CCD receiver and physically inhibited bench transmitter — circuit review

DRAFT: subsystem only. No bus bias or termination. J1962 / power / MCU are on other design blocks.

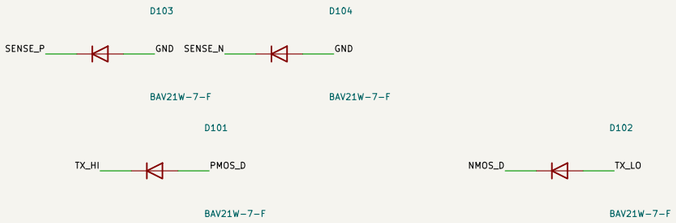
RX: CCD+ > CCD− produces LOW. 47k input impedance; no clamp to a local positive rail.

5V / 3V3 / GND are external supplies. CCD_P / CCD_N go to the protected vehicle connector block.

Vehicle transmission remains unauthorized. Synthetic model checks are not bench validation.

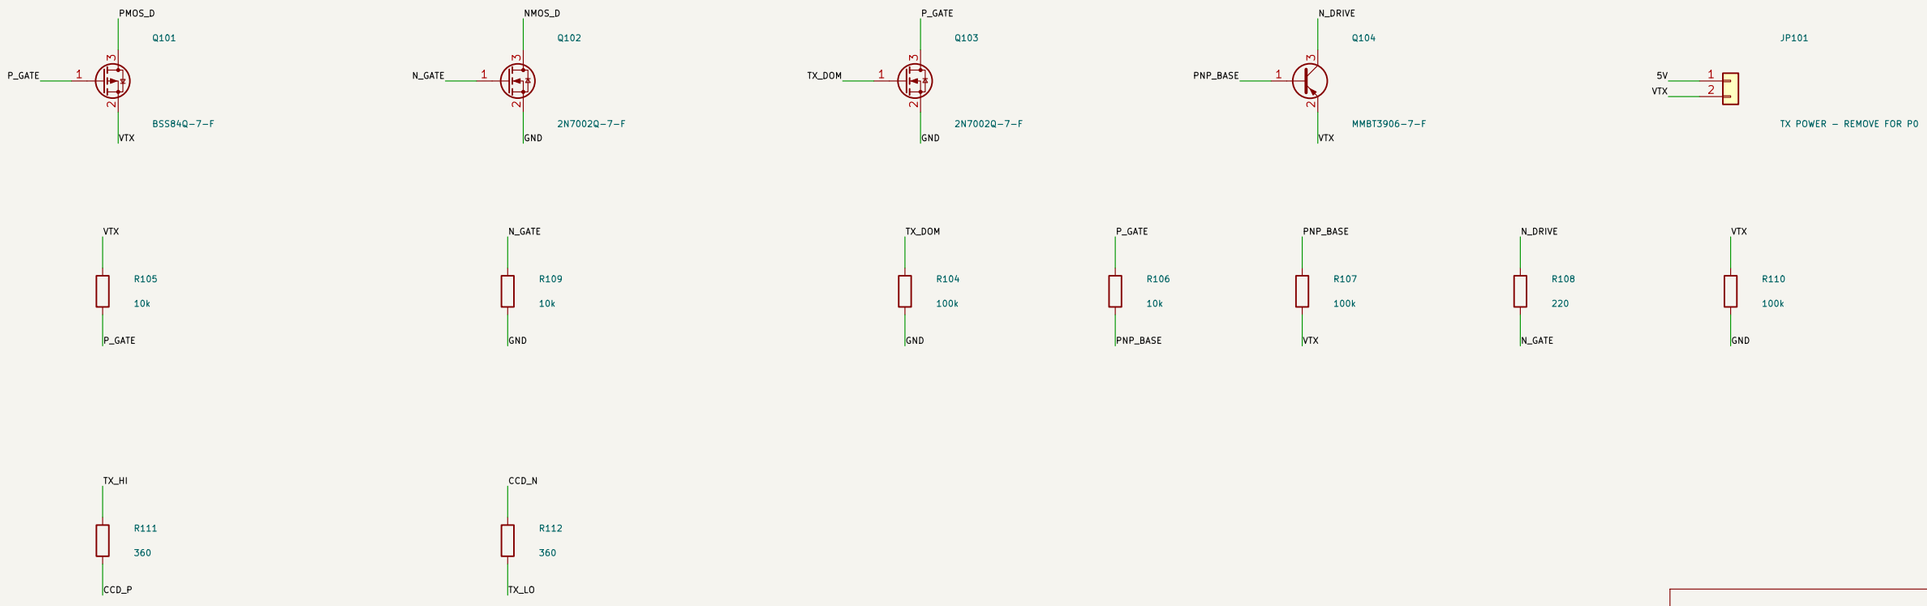
TX: active−high TX_DOM. JP101 absent disconnects the drive rail; both gates default OFF.
